Subject: **Bid #: 7946-W3, Green Hill Park Community Garden / DPWP**

### **ADDENDUM NO. 2**

**Project:** Bid No. 7946-W3 **Greenhill Park Community Garden**  
**City of Worcester Department of Public Works and Parks**  
**Parks, Recreation and Cemetery Division**

**General Bid Clarification**

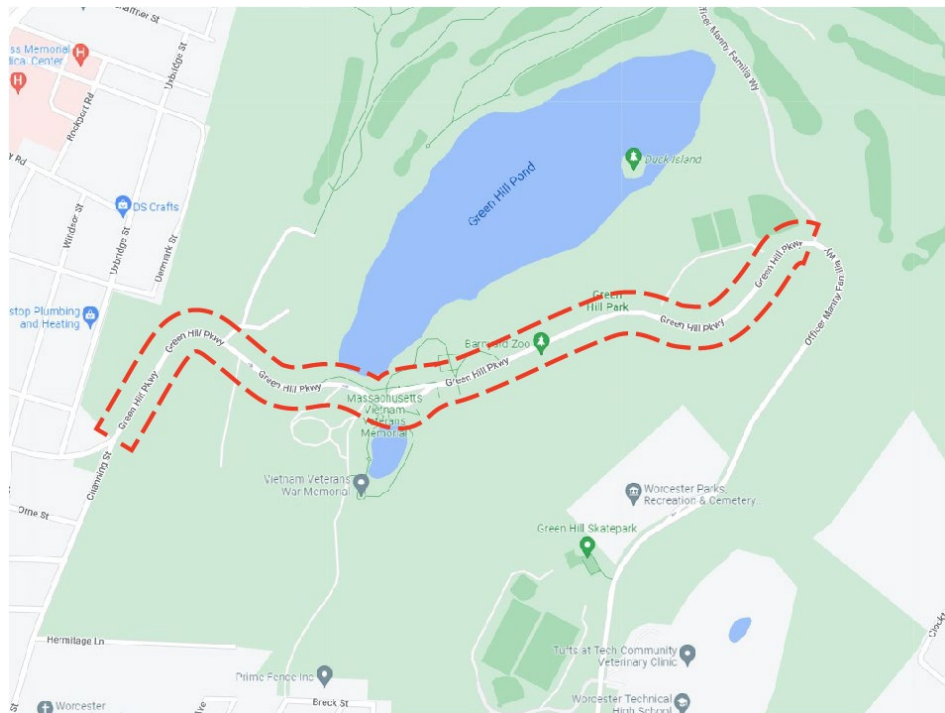
SHEET C001: - delete Add Alternate #3, Add alternate #4, complete.

**Add alternate #3:**

Contractor shall demolish existing hot mix asphalt roadway surface at green hill parkway, beginning at the intersection of Greenhill parkway and Channing Street (west entrance) and ending at the intersection of Greenhill parkway and officer Manny Familia way (golf course entrance), complete (approx. 120,000 s.f.).

The contractor shall supplement road base materials, adjust utility structures, existing curb lines, and fine grade base as needed, and provide new 4" depth vehicular hot mix asphalt pavement, as indicated in the details. Alternate #3 is not indicated in the drawings.

**Add alternate #4:**

Contractor shall mill and overlay existing hot mix asphalt paving surface to a depth of 2" at green hill parkway, beginning at the intersection of Greenhill parkway and Channing Street (west entrance) and ending at the intersection of Greenhill parkway and officer Manny Familia way (golf course entrance), (approx. 120,000 s.f.).

The contractor shall adjust utility structures as needed to provide a smooth, continuous, and well-draining road surface. Alternate #4 is not indicated in the drawings.

*Question 5: Please provide google earth limits of work for Add Alt 3 & 4. Including striping and details. Google earth is not current.*

Question 21: Can a plan be provided showing the limits of work required for Alternates #3 and #4?

**Answer 5:** Please see first page for diagram.

**Answer 21:** Please see first page for diagram.

L120

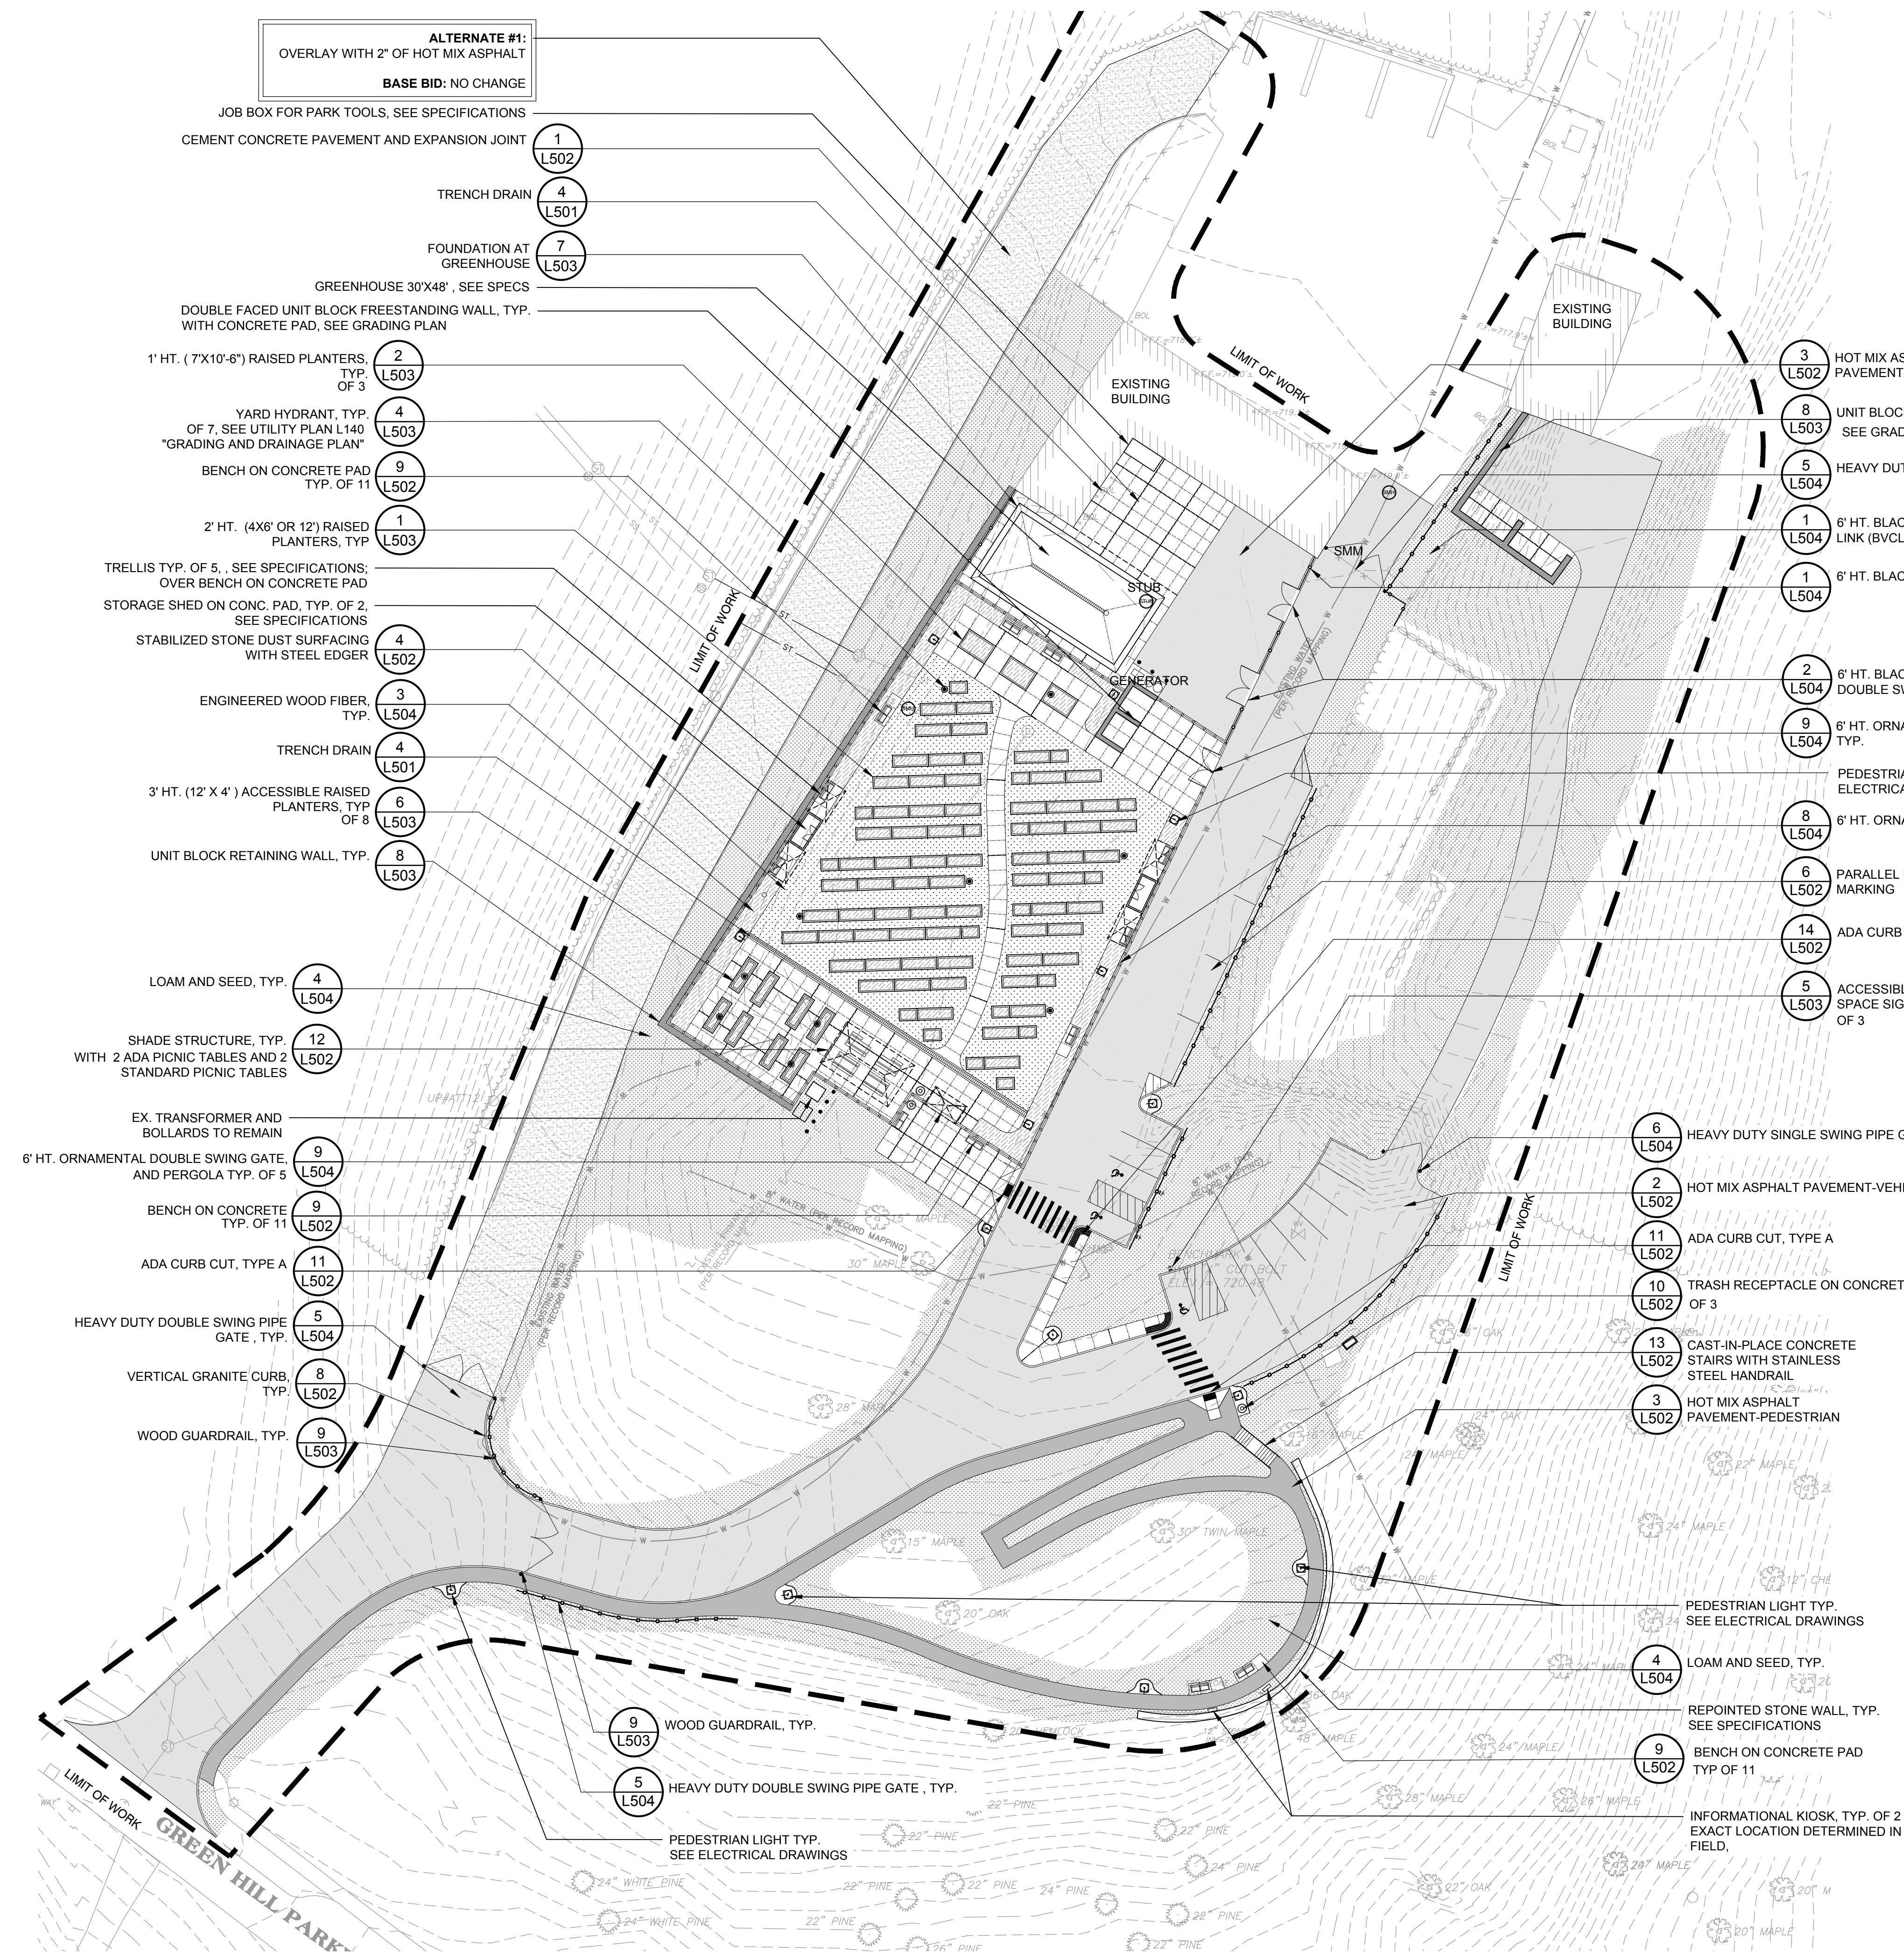
Question 9: Please confirm the 3 planters in the conc paving at the top of the park are 12" planters (Detail 2 on sheet L503) and not 24" height as labeled on the plans (L120).

Question 11: Please refer to Plan L120. The leaders on the left side of the plan reference only 24" Raised Planters. Are some of these planters supposed to be 12" Raised Planters? Also, the planters on Plan L120 seem to be drawn to different dimensions than what are shown on detail #1 and #2 on Plan L503. Please clarify quantity and size of planters.

Question 17: On Sheet L120 of the plans, the callout for the Greenhouse - 30'x48' states that this is "By Others". Section 13120 of the Technical Specifications state that the Contractor is to furnish and install the prefabricated greenhouse structure. Please clarify the work associated with the greenhouse to be performed under this contract.

**Answer 9:** Confirmed. Please see attachment 'L120 Material Plan'.

**Answer 11:** Please refer to revise drawings. See attachments 'Materials Plan L120' and 'Site Construction Details L503'.

**Answer 17:** Contractor to purchase and install the prefabricated Greenhouse as part of the project. See attachments 'Materials Plan L120'.

L130

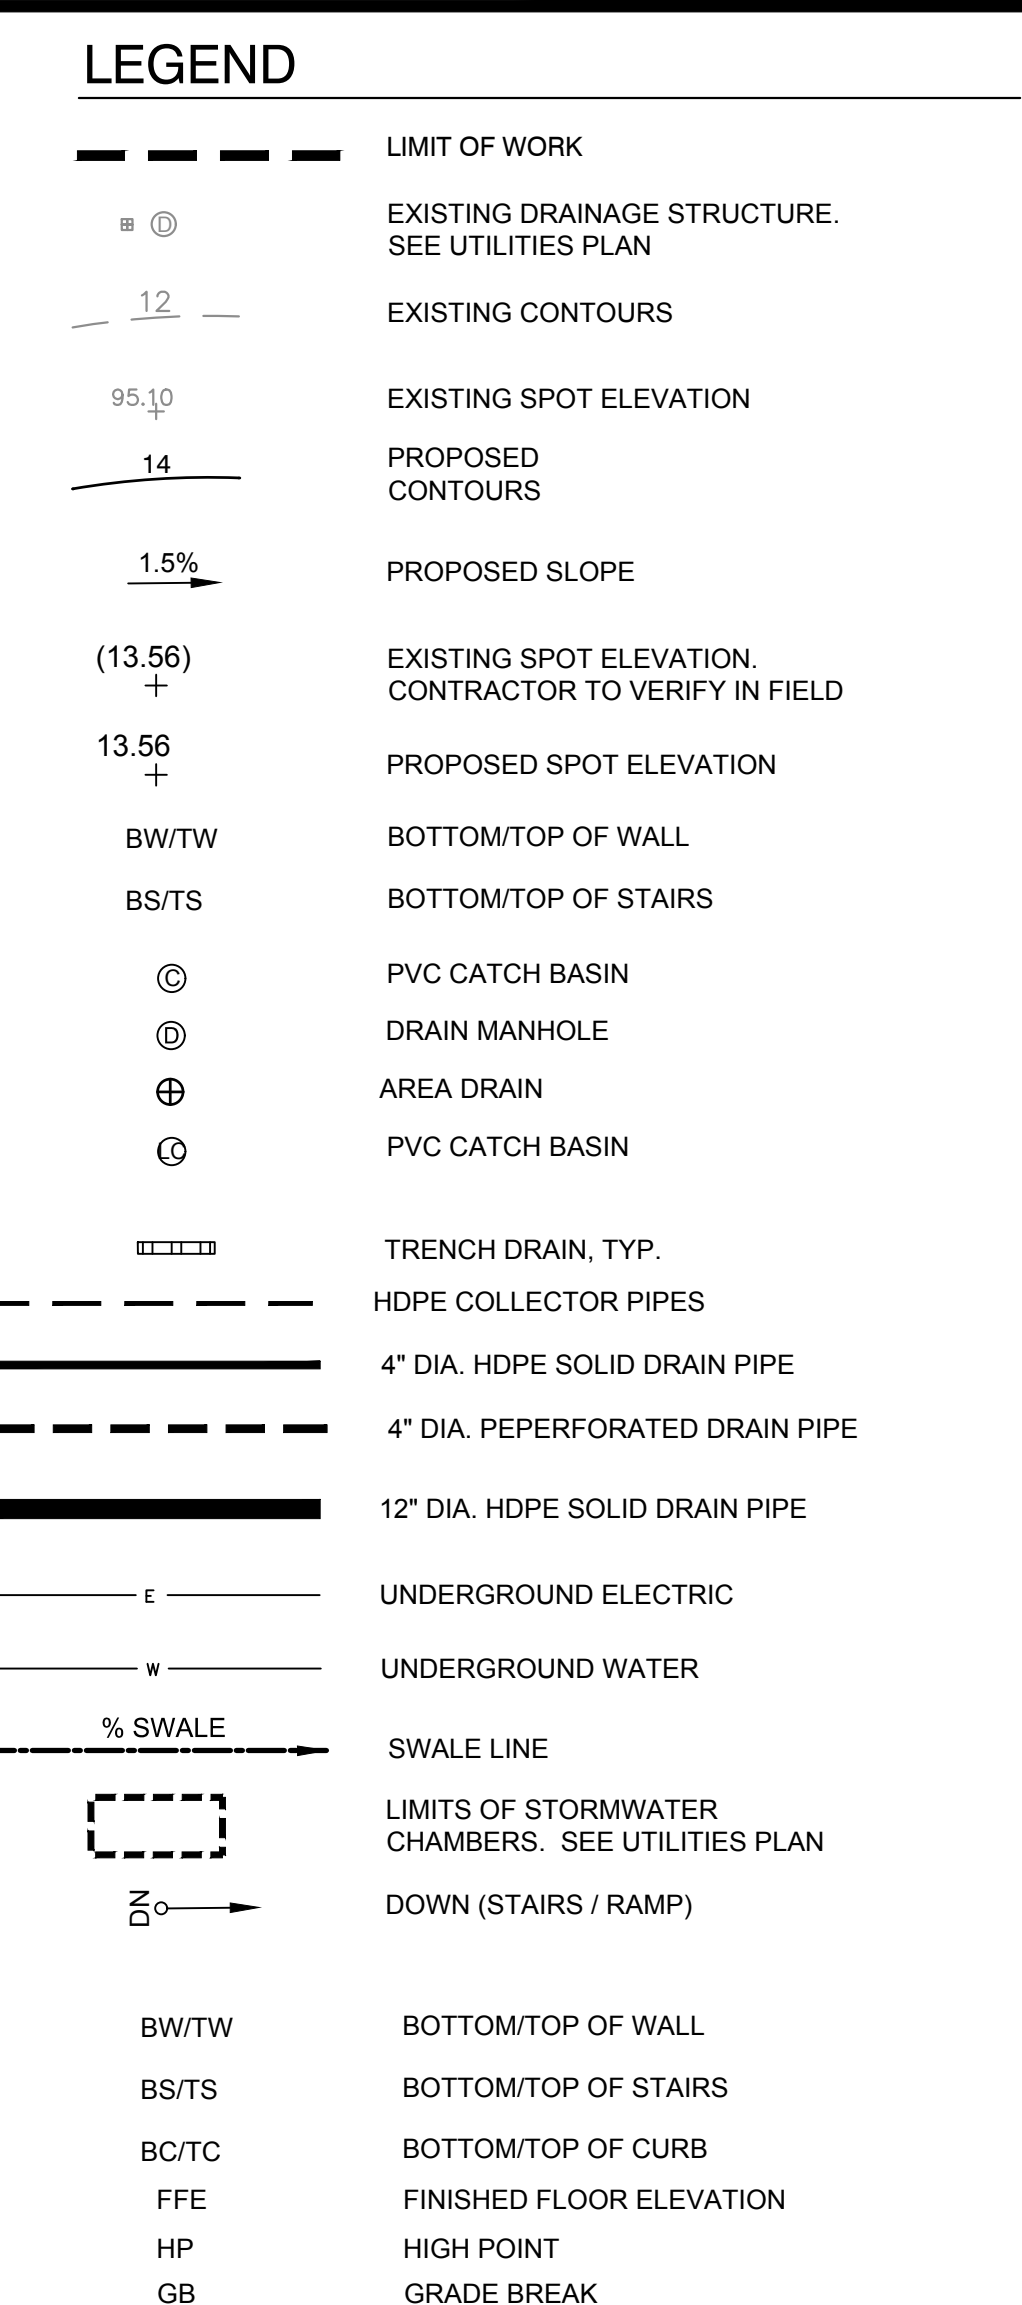
Question 12: Detail #7 on Sheet L503 shows the foundation required for the Greenhouse. The width of the footing is not called out. Please provide the width of the footing and stem for the greenhouse foundation.

**Answer 12:** Please refer to revise drawings. See attachments 'L130 Layout Plan'.
